# Road & Bridge Design Publications

## Monthly Update – April 2023

Revisions for the month of **April** are listed and displayed below and will be included in projects submitted for the **August** letting.

## APPROACH CURB & GUTTER DOWNSPOUTS

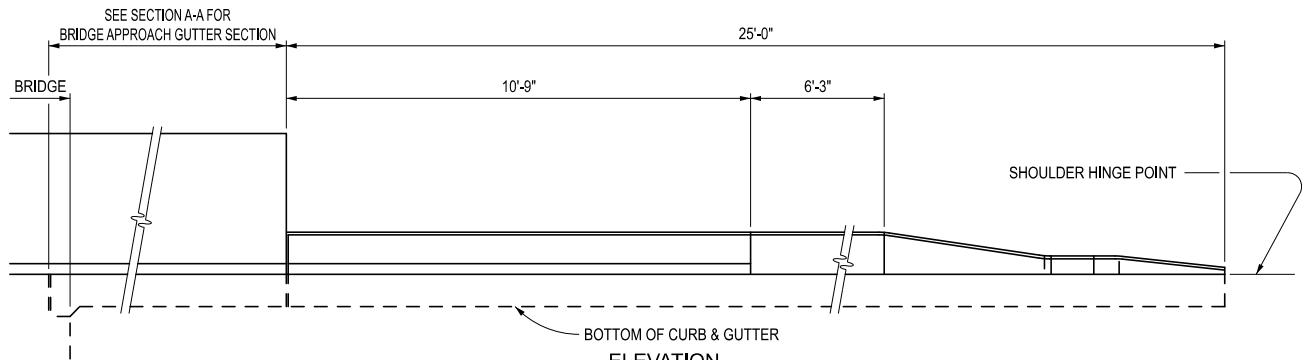
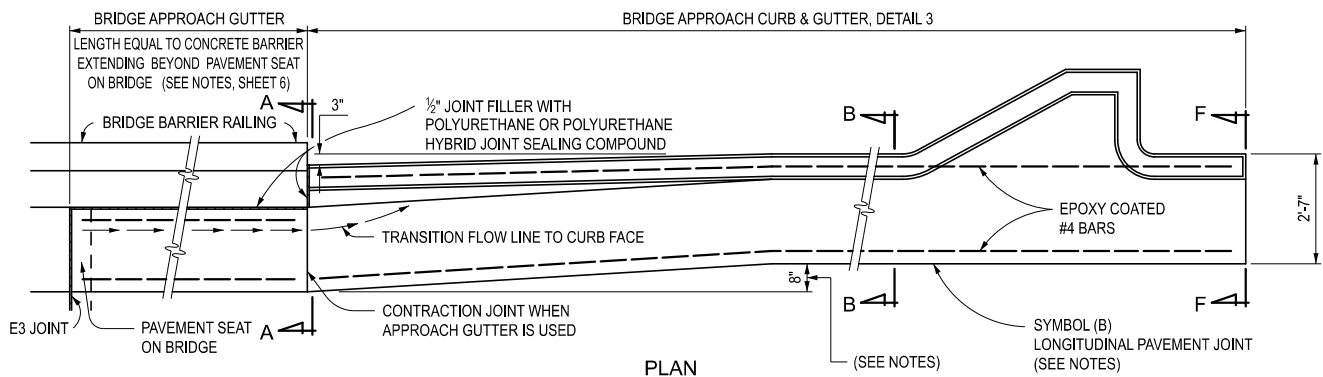
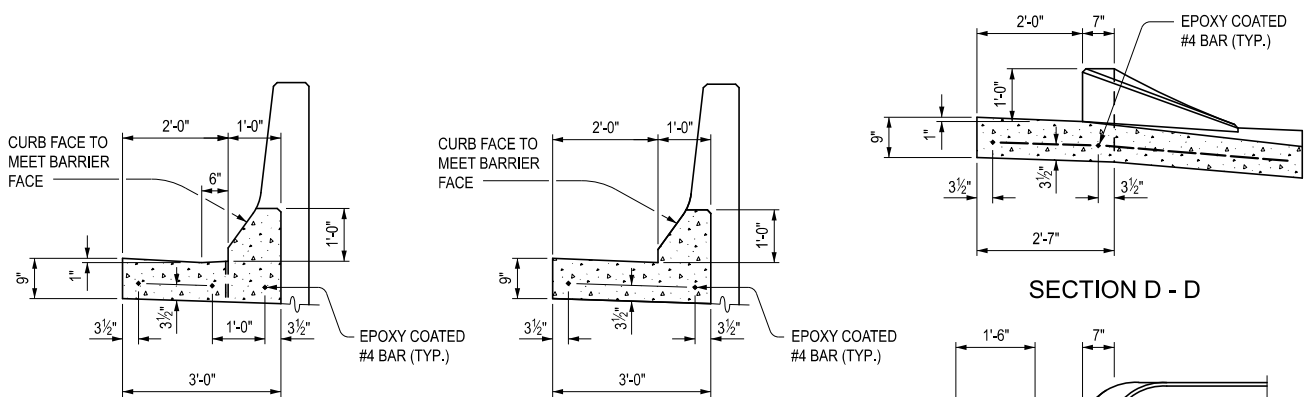
R-32-SD: Approach Curb and Gutter Downspouts (For Safety Shape Bridge Barriers & Railings): Revised the subtitle to reflect its use with safety shape bridge barriers and railings.

## CONCRETE PAVEMENT REPAIR

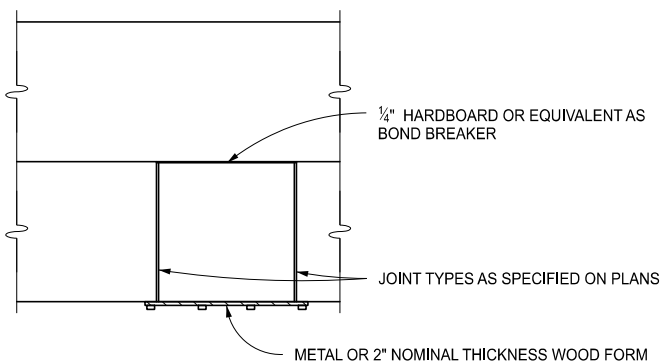
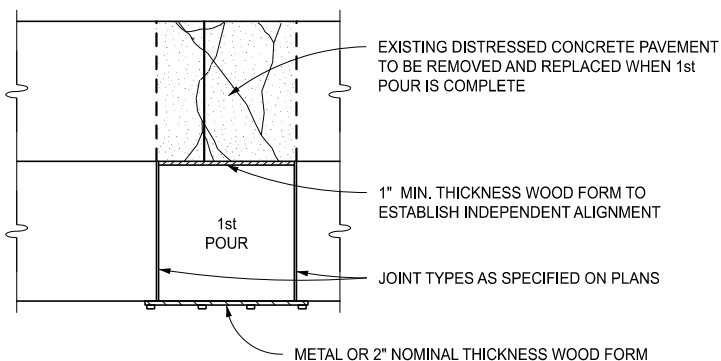
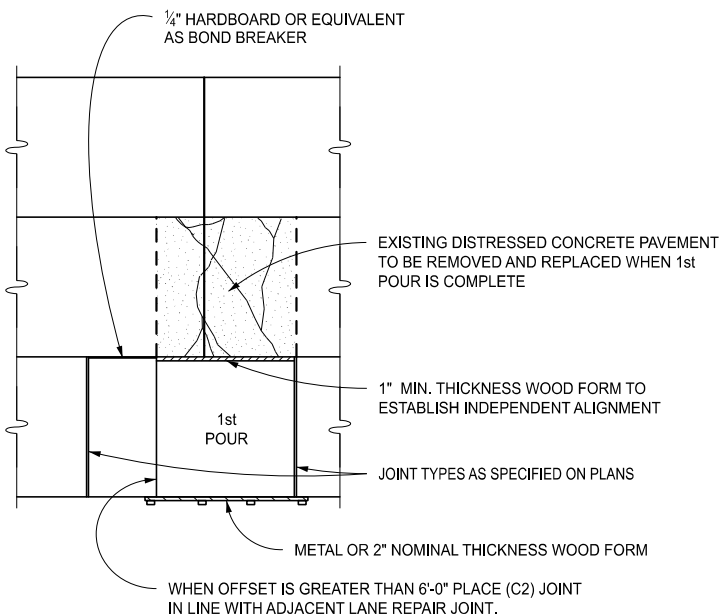
R-44-G: Concrete Pavement Repair: Revised the details to eliminate lift pin requirements, make the sawing diagram applicable to all full depth cast in place repairs, allow a 3" overcut into adjacent reinforced concrete pavements only, and revise the minimum length of concrete repairs from 4' to 5'. Also, revised the Detail 7 and Detail 8 repairs to require vertical edges by saw cut or other approved methods.

## GUARDRAIL MEDIAN OBJECT PROTECTION

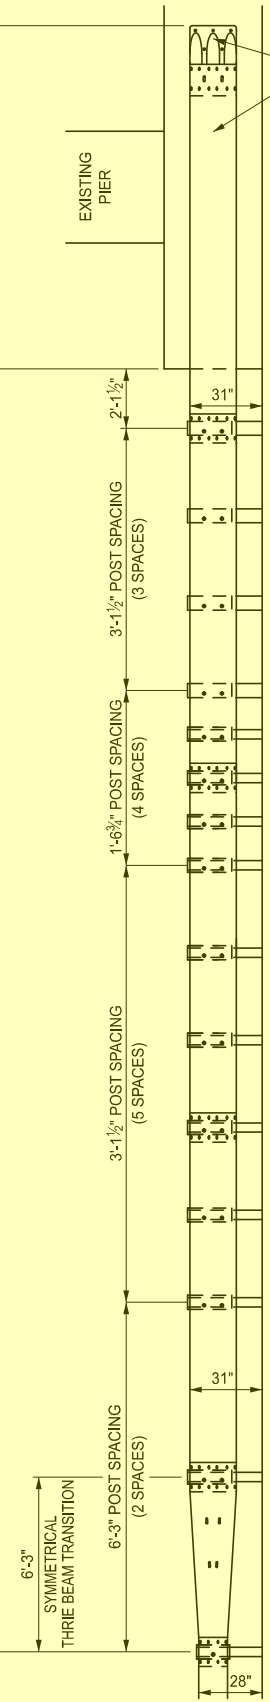
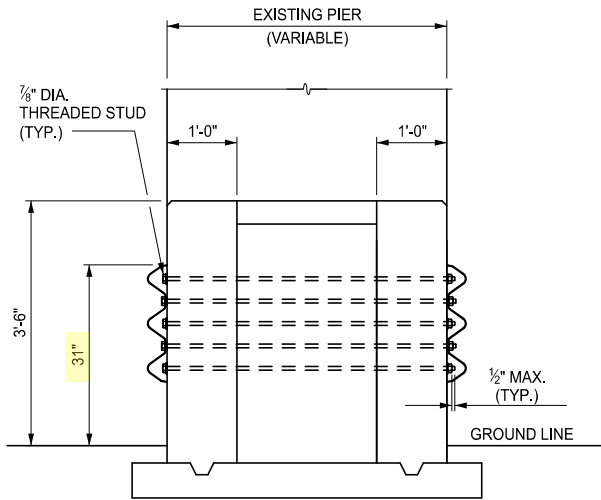
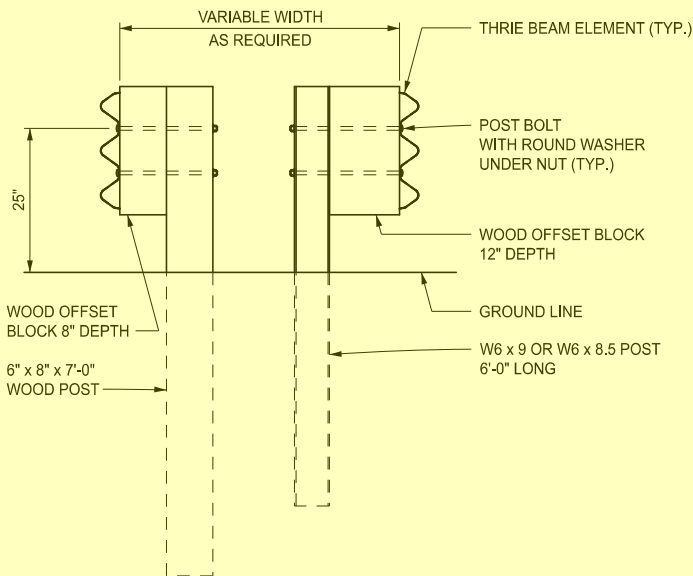
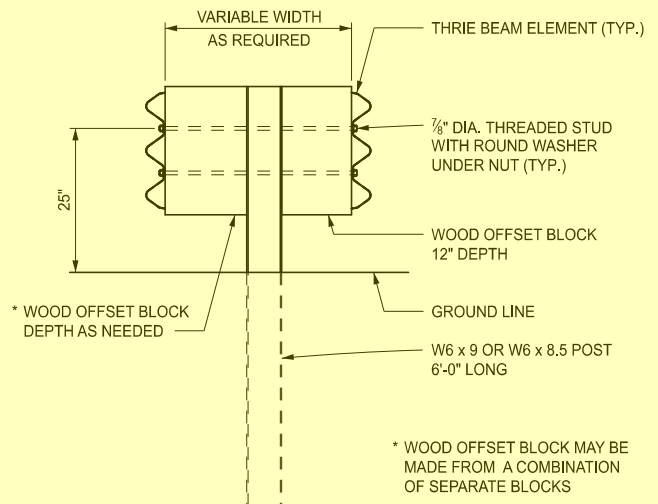
R-56-F: Guardrail Median Object Protection: Revised the details on Sheets 5 & 6 to show the "guardrail with direct connection to pier" using the standard Detail M9 anchorage instead of the former T6 anchorage.

**R-67-SD**

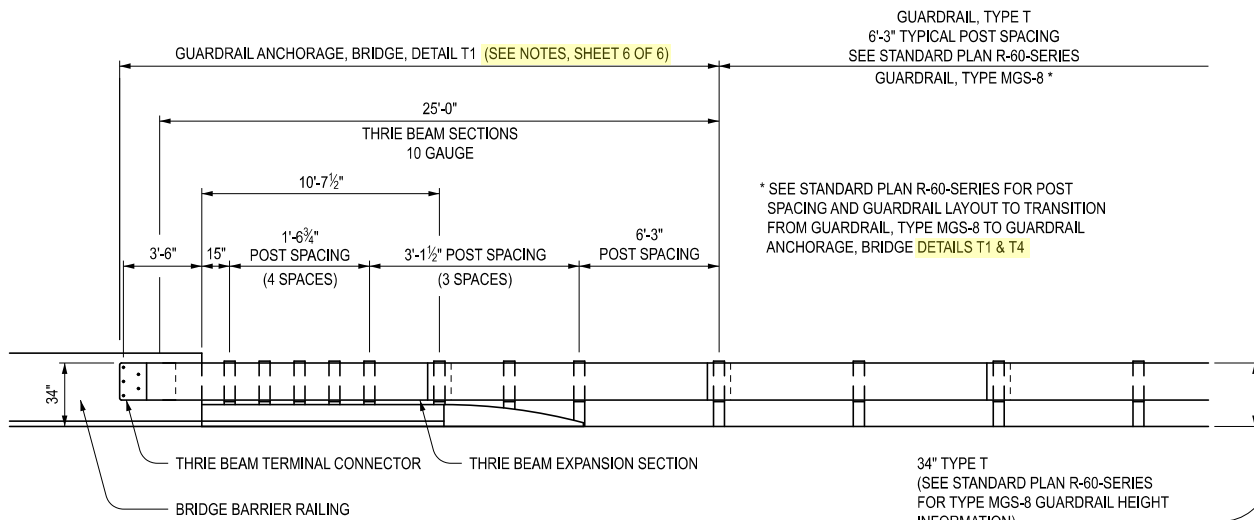
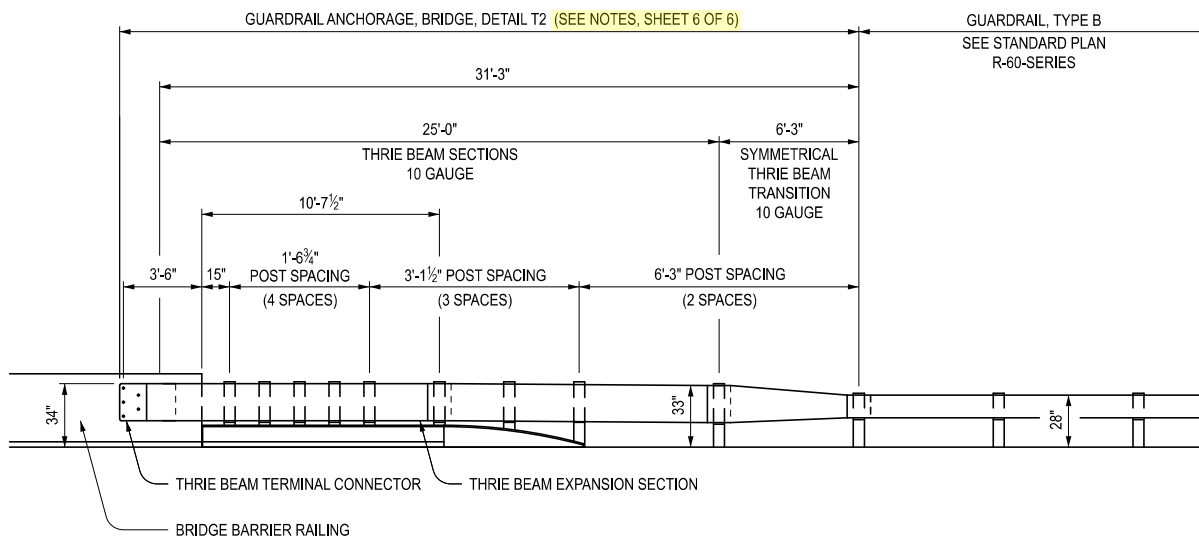
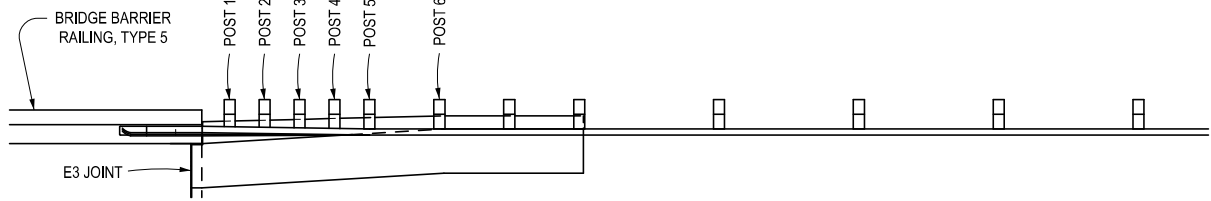
R-67-SD: Guardrail Anchorage, Bridge, Details (For Safety Shape Bridge Barriers & Railings): Eliminated details regarding connections to vertical walls since the details in R-67-series are the standard. Revised the subtitle to reflect its use with safety shape bridge barriers and railings.

### 7.01.06 (revised 4-24-2023)

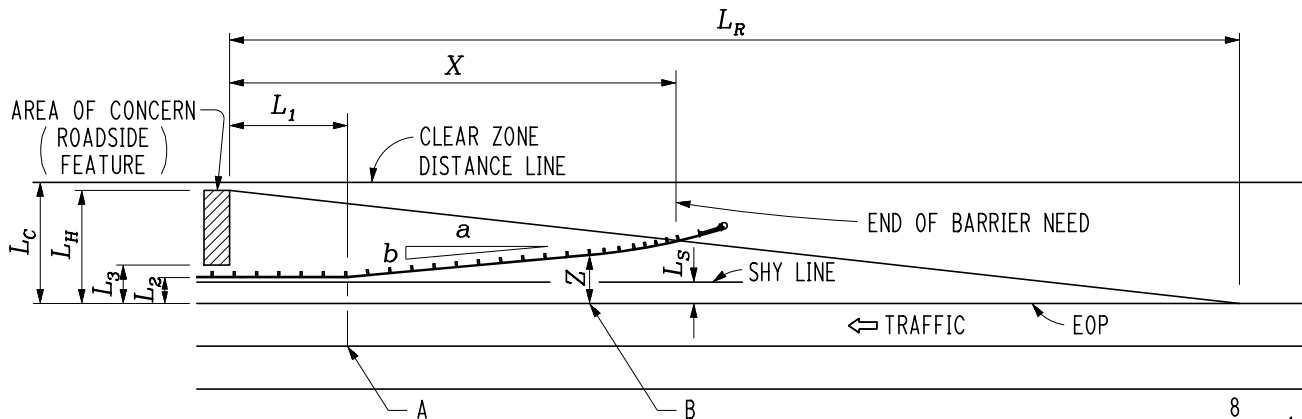
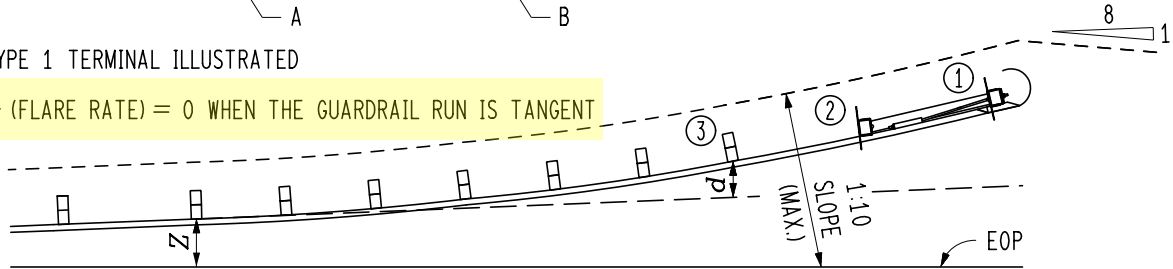
7.01.06: Guardrail Worksheet: Updated worksheet to include mentioning the flare rate is zero for tangent runs of guardrail (eliminated formulas for X & Z for Type 2 terminals), provided an explanation for determining the (L1) distance, updated the deduction table and notes, modified (simplified) the formula for "Z", and modified the name of the guardrail pay item. The worksheet itself was also upgraded to a fillable form.

## 7.01.41A (continued)

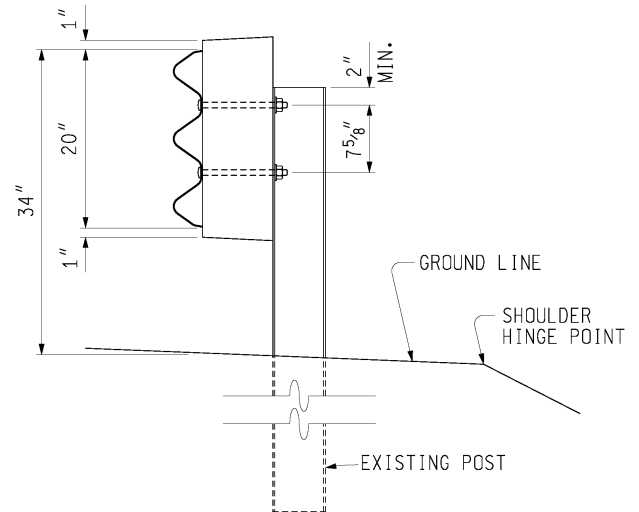
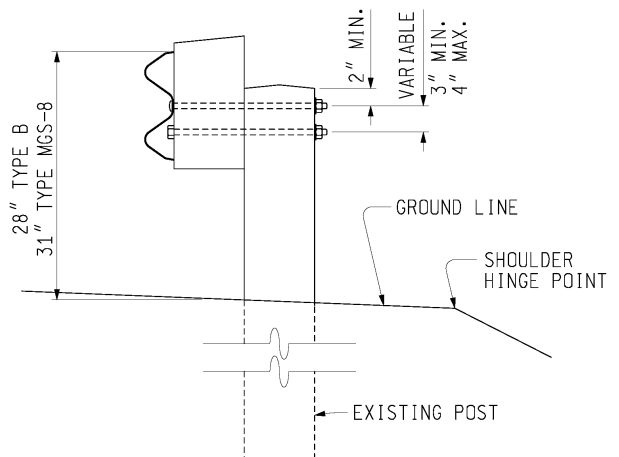
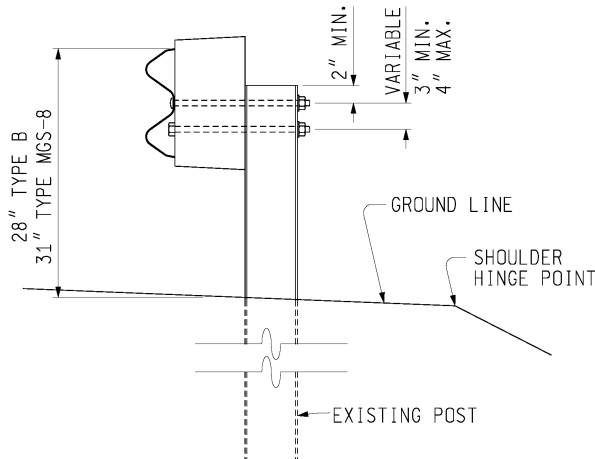
7.01.41A: Guidelines for Upgrading or Replacing Guardrail: Revised section for current guardrail types and practice. Also, revised the maximum distance between the upper and lower guardrail post bolts from 5" to 4" for Type B and MGS-8 guardrail on both wood and steel posts.
